Deerfoot Trail Study

Deerfoot Trail Phase 3: What we Heard

February 12, 2020

Beddington Trail N.E.

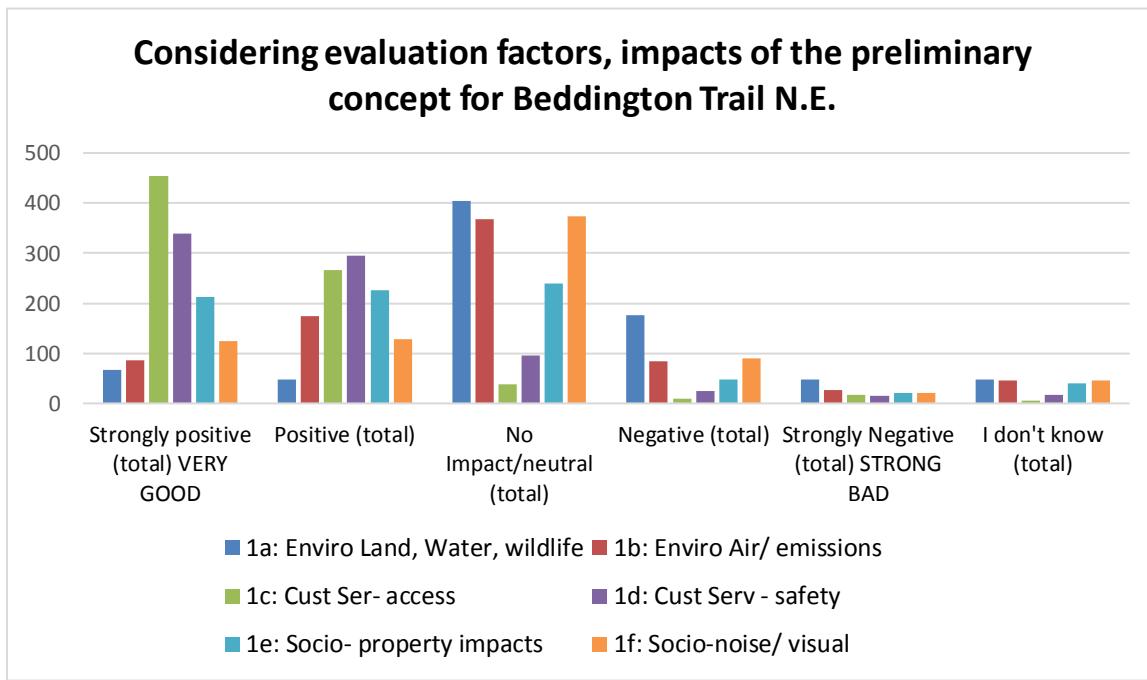
<ul style="list-style-type: none"> • Need to consider other options • The solution provided don't actually address the real issue of the interchange. The proposed

Overall General Disagreement *(About the preliminary concept for Beddington Trail N.E.)*

- solution provides more access, but does not resolve congestion, which is the main issue.
- I think there are other easy alternatives for people to access deerfoot from the Beddington area
- Stop wasting money on building for more traffic
- This concept doesn't make sense. There schematic implies that SB and NB Deerfoot traffic will come together at the same time as NB 11 Street traffic to go WB on Beddington Trail.
- Shouldn't you be looking at the weaving that happens when traffic coming from McKnight as well as 64th Ave enters into Deerfoot Tr N and traffic exiting at Beddington? how about a "collector" lane?
- Expanding highway infrastructure induces demand and does not result in meaningful improvements.
- Seems like overkill to provide all-access interchange from/to 11St NE - seems like a limited area that will benefit from these improvements. \$ better spent elsewhere.

Suggestion to the Draft Concept *(Beddington concept-specific suggestions)*

- We like the proposed design, but would like you to consider taking southbound traffic on Deerfoot that needs to exit to 64th Ave, please provide an exit lane before Beddington Trail. This would greatly eliminate weaving of traffic and conflict between traffic merging onto Deerfoot from Beddington and Traffic exiting for 64th Ave.

- I live in Beddington. I would use a connection from EB Beddington to NB Deerfoot very infrequently and probably on weekends only. Going south to 64 Ave and then turning north is fine.

- As for Deerfoot Tr. Improvements at Beddington Tr. you should consider making an exit from Hwy 2 South to 64 Ave. just after Airport Trail North of Beddington. Take the exit under Beddington and alongside of Deerfoot Tr. This area is a total mess because 2 lanes of traffic from Beddington is trying to get into Deerfoot while cars from Deerfoot South are trying exit to 64 Ave. lot of mix and mash as this point. If you make exit fro 64 Ave before Beddington entry to Deerfoot you will gain free flow from Beddington on to Deerfoot Tr. and no trouble for exiting cars to 64 Ave.

McKnight Boulevard N.E.

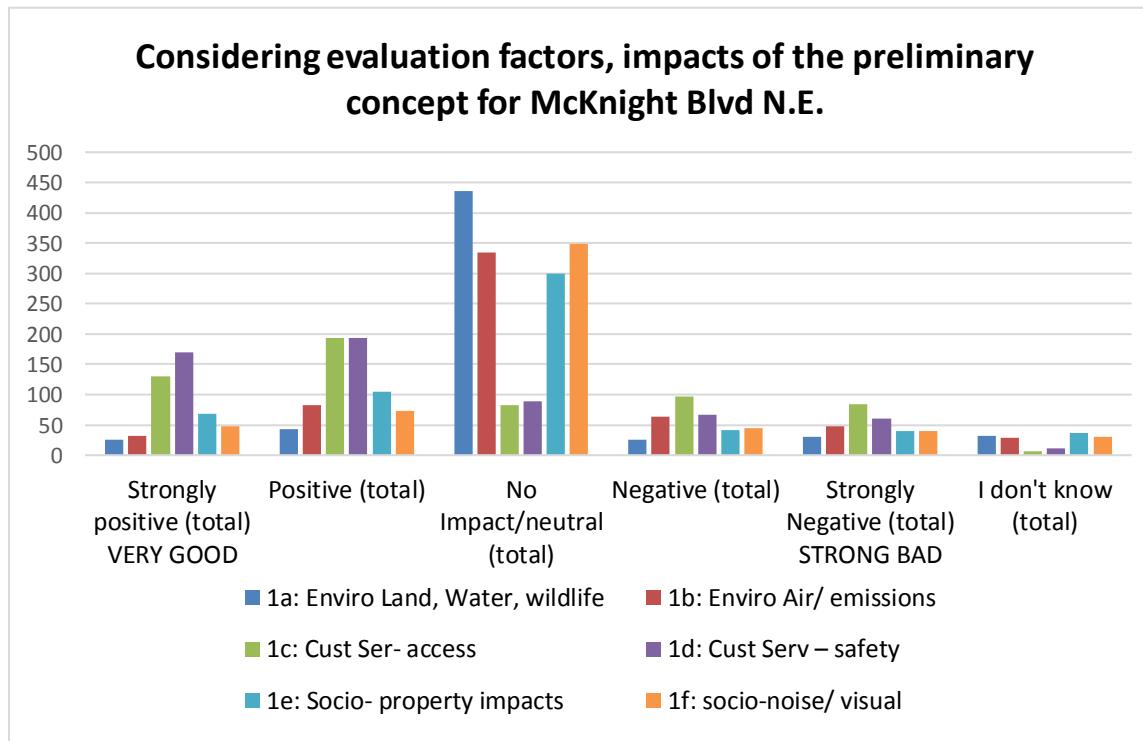
<p>Overall General Disagreement <i>(About the preliminary concept for McKnight Blvd. N.E.,)</i></p>	<ul style="list-style-type: none">• Do not support not being able to go northbound deerfoot to eastbound mcknight• Very little change, I would expect very minor improvements to traffic. I don't see anything addressing the greatest bottleneck: merging onto Deerfoot Trail Northbound.• I think this area is a lower priority than the other areas in Calgary, and by changing the interchange in this manner will not relieve the issues on deerfoot trail.• No reason to remove the free flowing traffic coming off of Deerfoot to head east on McKnight. The project would be much cheaper if you left this as is.
<p>Suggestion to the Draft Concept <i>(McKnight Blvd. N.E. concept-specific suggestions)</i></p>	<ul style="list-style-type: none">• North to South: At the moment one lane is lost underneath the McKnight intersection - 4 lanes need to continue all the way down. This is causing a natural bottleneck pinchpoint. Very important is that 4 lanes continue underneath the McKnight intersection all the way south!• Do not remove the ramp NB Deerfoot to EB McKnight. ADD a clover leave from EB McKnight onto the center of Deerfoot to remove traffic lights on McKnight• WB on McKnight to NB Deerfoot - need another lane for congestion reduction & separate lane (CD) for McKnight to 64th• Exiting off McKnight Blvd. to Deerfoot N should have a continuous lane onto 64th Ave as this has lots of accidents. Turning left onto McKnight can cause congestion if traffice flow is heavy• Widen the southbound collector lanes to reduce weaving• I think if you want to do this, then you should utilize a full clover leaf. The intersection with spiral honestly may not have the effects you want, and your quick off ramp is the best option for flow• Access from McKnight to Deerfoot northbound needs to be fixed. A through lane to 64th Ave needs to be added. Right now this is the primary cause of Deerfoot northbound being backed up.

Problem Identification

- Getting across Deerfoot Trail in the afternoon rush, is a nightmare as at the Westside of Deerfoot Trail McKnight becomes a regular city roadway with many traffic lights that creates a bottleneck for traffic that wants to go beyond Deerfoot Trail for example to go to John Laurie Blv.

- Merging onto Deerfoot north from McKnight is a nightmare and often the cause of Deerfoot trail backing up and slowing down all the way to memorial
- Deerfoot trail needs 3 dedicated lanes here, left turns are the most inefficient of traffic moves. How can you say that removing an entire turnoff, and making it a red light left turn, an improvement?

- This area is always a problem both ramps are always congested.
- The exit from McKnight to Deerfoot North needs improvement. I would suggest a lane that goes straight through to 64th May help with the congestion that causes most of the back up during evening rush hr.

- The problem with the McKnight exit is that it does not have a long enough merge lane onto Deerfoot trail northbound. All the traffic for rush hour on Deerfoot is because of this one issue.

- Simple solution would seem to be to extend the far right merge lane going Northbound on Deerfoot coming off of McKnight right up to 64th and beyond. It ends for no particular reason, then new lanes.

16th Ave. North

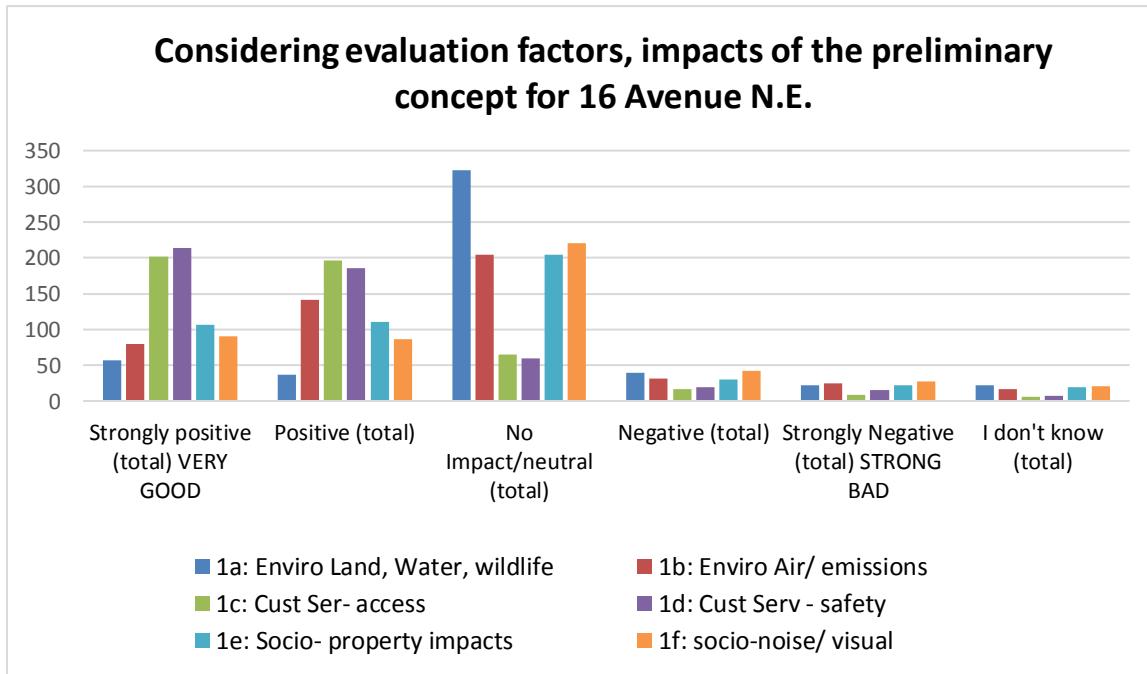
General Disagreement

- Save the money. The road is fine. There isn't a lot of congestion here. People are just anxious and impatient. Interchange here would discourage people from going to Mayland Heights.

- Does not look like it solves anything, just causes more confusion.
- This appears to be a lot of money and work, along with a lot of short term traffic disruption, for extremely little long term impact. This would be huge waste of money.

- current plan is a stupid design, this interchange needs to be a cloverleaf, the current design is dangerous and ineffective

Suggestion to the Draft Concept

- The distance between merges and drivers on the ramps between the basket weavers and 19th st seems way too short
- this doesn't address the issue of slow downs that occur N bound b/w Memorial and 16th every single day after work hours

- love the concept and would definitely allow for more of a free flow but would like to see a better north bound off ramp
- The proposed interchange at 19 St NE & 16 Ave NE alone would accomplish 90% of the benefits of this concept. No need for weaving bridges or the bridge across Deerfoot (or that can be determined later)

- While this deals with east/west traffic, it does not address traffic going to/from Deerfoot. Fixing one problem while ignoring the other is wrong. Fix BOTH at the same time.

<p>Traffic Lights/Signals General Disagreement <i>(Unsupportive of traffic lights and signals presented in the draft concept at 16th Ave N.E.)</i></p>	<ul style="list-style-type: none">• Would rather see cloverleaf for on/off ramp access. Not in favour of having any lights at these intersections.• signal timing is poor now and not likely to change much with the concept. stopping at 3 lights sucks. meter the nb entrance ramp to deerfoot in the pm peak as that really impacts flow on deerfoot• through traffic should be separated to avoid stop lights. also removes chance of people using turning lanes to try and beat through traffic.• Just get rid of the traffic lights, they're annoying.

17th Ave / Memorial Dr. SE — Three Preliminary Concepts

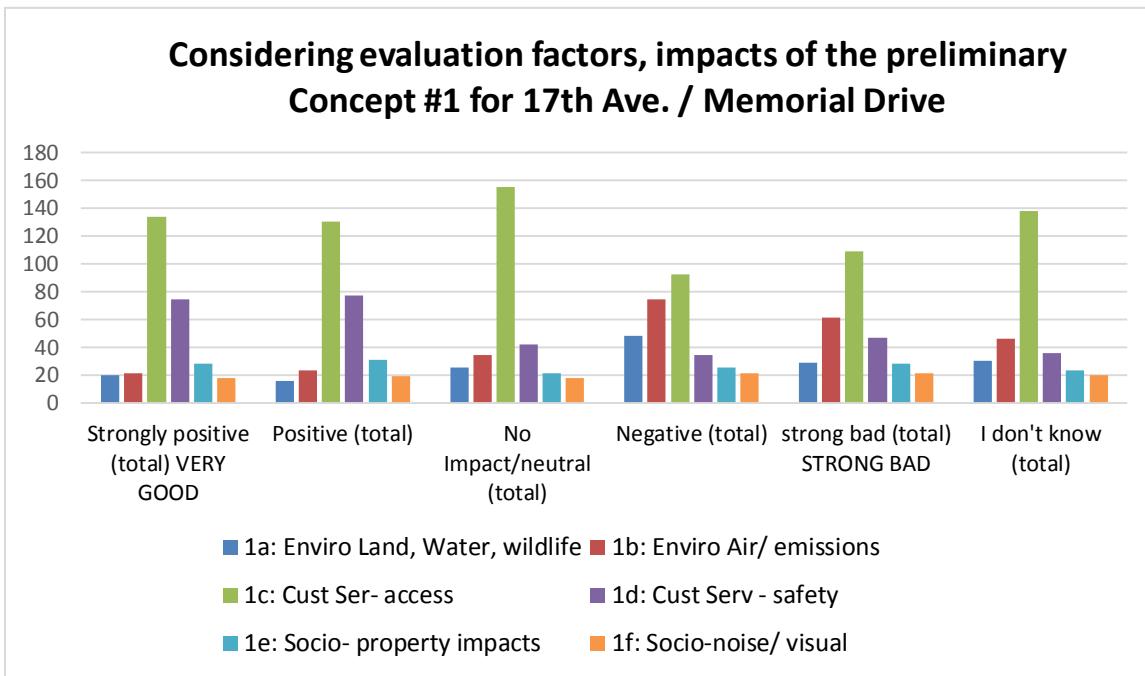
Top Themes That We Heard	Participant Verbatim Comments
<p>Overall General Agreement <i>(About concepts for 17th Ave / Memorial Drive)</i></p>	<ul style="list-style-type: none">• I used to use this a lot. Improvement would really help.• I use this intersection every day, it's terrible. Any of the proposed concepts would be a significant improvement, SOMETHING should be done.• The trip from Memorial to Glenmore during rush hour is PAINFUL. The weaving of traffic is nerve-wracking and I'm sure a major source of collisions. Basically any chance would be an improvement.• At this point it can connect Barlow and Blackfoot which are alternate routes for Deerfoot.• Option 3 has the least impact and appears to be the most elegant solution.• Currently it is a death wish. Separate entry and exit is important. Overdue upgrades need to start soon. Everyone is scared to take deerfoot daily.• This area needs an overhaul; at first glance concept 2 seems like the one which would result in the greatest improvement.• These intersections are some of the most poorly designed and busiest intersections in Calgary. They need to be freeflow interchanges as much as possible. Option 2 is as close to ideal as possible..• Concept #3 looks like it makes the most sense as it fixes the flow of traffic without changing the main access and departure lanes too drastically.• Less lights the better. More skip ways instead of lights and lane reversals• Traffic clogs here daily. Costs shouldn't be a factor when improving the area. Do the best you can the first time to eliminate costly

<p>changes in the future. Do it right the first time. Concept 1 best.</p> <ul style="list-style-type: none">• This is the most problematic intersection, trying to get onto northbound deerfoot can take up to an hour• during rush hour this is a total disaster accidents waiting to happen, especially people coming off deerfoot to memorial, it's so hard to move at rush hour and a lot of people won't let you in.• On the first 2 concepts, I like the idea of eliminating the Memorial Drive exit lanes and moving them effectively to Barlow Trail.
<p>Problem Identification <i>(About concepts for 17th Ave / Memorial Drive and areas of concern in the interchange area)</i></p>	<ul style="list-style-type: none">• These three concepts worry more about South of Memorial Drive. The main issues with the ENTIRE Deerfoot starts with the section North of Memorial Dr. The small off ramp from EB memorial to NB Deerfoot starts a chain reaction for congestion and accidents for the entire roadway. Vehicles cannot gain enough speed to properly merge with other vehicles doing 100km/h on the Deerfoot.• I actually feel preliminary concept #3 is the best one to address the weave in both directions of Deerfoot Trail, with the least impact on the west and east side of Deerfoot Trail. However, the intersection at Southbound Deerfoot and Memorial (specifically the configuration of the LRT tracks and where to stop safely for the lights) remains unchanged. This is a very dangerous design in its current state.• Scenario #1 - All this does is displace traffic onto Barlow. Additional light DD interchange will add confusion. Will not solve traffic off Deerfoot only creates backlog, people• You need that south ramp on to deerfoot, not create a mess inside the neighbourhood exiting to get to memorial. Interesting but waste of money, won't solve issues.• Scenario #2 - Like Blackfoot to Barlow. Being forced to exit @ 17th and Barlow to Memorial will not solve any issues. Double people exiting 1 exit instead of 1/2 @ exit and @ other will just make backlog between 17th and Peigan.• Option 1 and 2 would create too much traffic on Barlow trail. That area is prime for densification and should be focusing on improving access for transit/walking. I'd like to see the LRT crossing gone

<ul style="list-style-type: none">• Considering that Calgary Transit users pay a user fee to cover 50% of the operating cost, why not ensure there is a user fee to cover 50% of costs to anyone using Deerfoot?• Concept 2 appears to have bottlenecks going to/from southbound Deerfoot. Only a single lane in each direction. Due to that I support Concept 1 or 3. One benefit of 1 is Barlow will be easier to access• None of these plans address the congestion westbound 17th avenue over the river. Widen the bridge to 3 lanes westbound to accomodate all the westbound traffic or all this work won't solve anything.• Concept 1 would create the best situation however access to Max bell might be difficult from the north or south--maybe open an access off of memorial?
<p>Suggestion to the 17th Ave S.E / Memorial Drive Draft Concepts <i>(To specific concepts 1-3 or overall interchange area)</i></p>	<ul style="list-style-type: none">• Concept one would see the greatest increase in traffic flow and would manage it seamlessly. I would like ot see a lane added from north bound Barlow to south Barlow to keep traffic of deerfoot (N and S).• I believe #2 is the best choice for improving traffic flow and providing options for routing trating in incidents of traffic disruption. I would suggest 2 modifications for concept #2: have 2 lanes exit from NB Deerfoot to NB Barlow; explore if traffic circles instead of lighted intersections wouuble be better on either end of the Blackfoot Trail Bridge over Deerfoot.• Concept 3 is the most common sense and lowest overall impact. The route continuity broken by Concept 2 doesn't make as much sense and it is a nightmare to sign. It seems unlikely that a signalized intersection will handle all 17th ave traffic at the ramp traffic all turning. The diverging diamond is a good idea.• Build flyover from eastbound memorial to north bound deerfoot and make it 2 lanes. (concept 1 - prefer, concept 2 - neutral, concept 3 - NO)• On the first 2 concepts, I like the idea of eliminating the Memorial Drive exit lanes and moving them effectively to Barlow Trail.• What about getting rid of a canal of the side and that way they could be more lanes going through• The 17th/Memorial lanes create backup because of weaving and short ramp. Only concept 3 adequately deals with this. Concept 2 is OK, but

I hate the weave bridge--one over McLeod is confusing.

50 Ave. / Peigan Trail - One Preliminary Concept

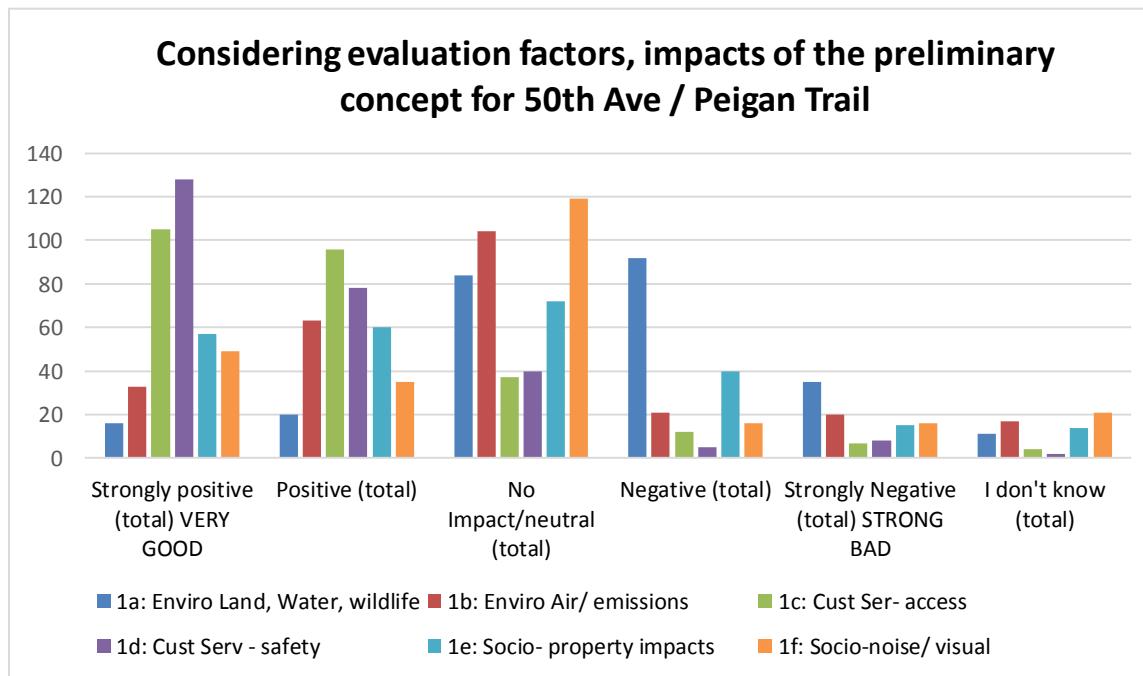
<p>Prioritize other interchanges over 50th Ave / Peigan <i>(Not a priority area compared to others in the study)</i></p>	<ul style="list-style-type: none">This is a low priority project, however it would also improve safety over the bridge by reducing the turn radius.this seems like a nice proposal but should be low on the priority listNot really a priority but can be considered in the future. For bigger project for anticipation of population growth. A good point for alternate access because it is in a midpoint.This intersection is already fine. Quit spending money for the sake of spending money.Not sure that this needs doing right away, but would be a nice improvement

<p>Problem Identification <i>(To preliminary concept for 50 Ave / Peigan Trail and interchange area)</i></p>	<ul style="list-style-type: none">• Will the proposed new bridge take into consideration the angle of the sun during sunrise/sunset? I like that the calrofe bridge will be used for another purpose.• If I'm understanding the map correctly, this gets rid of Peigan Trail/Deerfoot's access to each other. Would improve flow, could impact navigation for those leaving industrial area. Not sure I'm a fan• Access to parks is still required• The major cause of delays and accidents in this area are Pegian trail exit to Deerfoot N, deerfoot South exit to Pegian trail. This concept does not address these problems.

- This access would be great for cars & people & cyclists, but the river would suffer due to debris, eliminated animal habitat, etc. Can pre-fab construction methods be used to minimize time/impacts?
- Having a more connection to the industrial area west of Deerfoot, as well giving that side a more direction connection to east of Deerfoot is ideal
- Seems like a bad location to seek to make these changes. Icy conditions and high flood water area with a design that doesn't plan for this.

Glenmore Trail S.E. - One Preliminary Concept

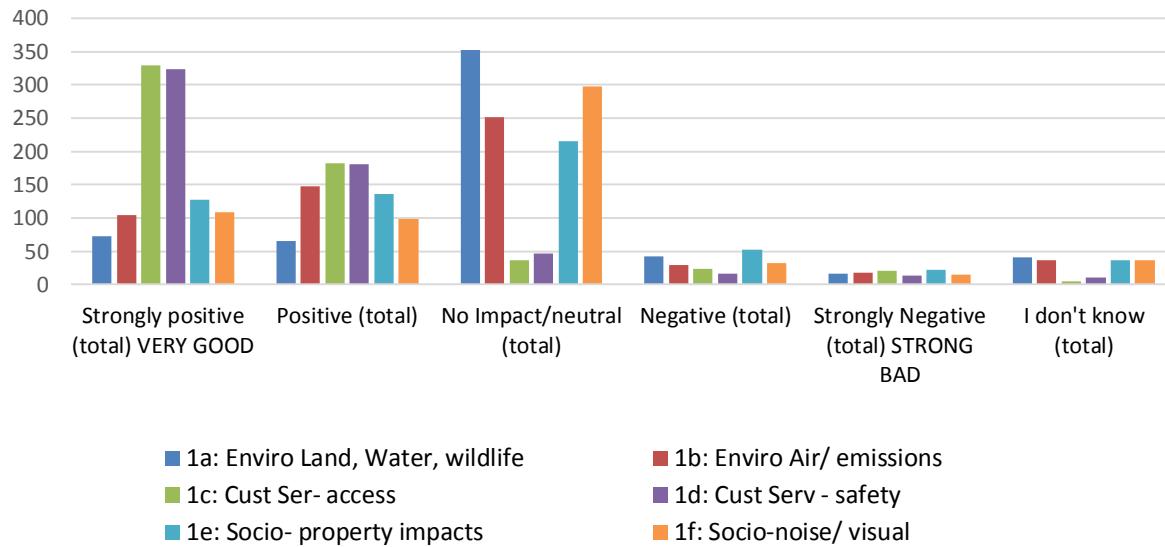
Top Themes That We Heard	Participant Verbatim Comments
	<ul style="list-style-type: none">• Looking forward to the elimination of the "Glenmore Squeeze". Northbound to Westbound movement very much improved. This is probably the highest priority, followed by Anderson/Bow Bottom.• This concept is so much better than the current design. It would greatly improve traffic flow.

<p>Overall General Agreement <i>(About preliminary concept for Glenmore Trail)</i></p>	<ul style="list-style-type: none">• This is one of the most critical interchanges in Calgary and desperately needs upgrading. The need far outweighs any potential negatives regarding property impacts or environmental considerations.• Current access sucks, needs improvement. This is a good proposed change.• Improving flow from NB Deerfoot to WB Glen more would be life altering. The time spent here is ridiculous. Bike pedestrian traffic could be diverted to Heritage as it is more likely to have traffic• Great to remove the detours through industrial/retail and condense all traffic to within the interchange• This should have been implemented back in ~2008. I support this to get rid of one two-lane pinch-point on Deerfoot.• Glenmore Trail...another historically normal road that we turned into a freeway, and somehow the traffic got worse. Build it, and they will come; alternatively, do not build it, and they won't..save \$

<p>Problem Identification <i>(Particular areas of concern in and around Glenmore Trail S.E. interchange and area)</i></p>	<ul style="list-style-type: none">• I think because the changes necessary to make this interchange more effective are so huge, it has been ignored or underserviced for a long time. Not much about the current interchange works well and as Quarry Park becomes busier and more traffic heads East of Deerfoot it seems that a crisis point is almost being reached here.• Avoid long back up of traffic - causes air pollution. More direct. Avoid a traffic light, in winter causes slippery road conditions, everybody stopping and starting in the same place.• I believe this intersection is one of many significant bottlenecks on Deerfoot and could use a major revamp• Like exiting Deerfoot N to Glenmore W (3 lanes each?) rather than Heritage Dr currently. Do not like Blackfoot N interchange turning left to get to Glenmore E, then Dft S (too much weaving)• The exit from Deerfoot south to Glenmore, going on Glenmore west is slow and high risk, especially coming off of the ramp to merge into Glenmore. The yield sign is almost a "stop" sign and a high risk "accident" area.• The interchange will change how to get to Glenmore. Going through Heritage now and snaking to Glenmore is a time waster. It isn't efficient at all.
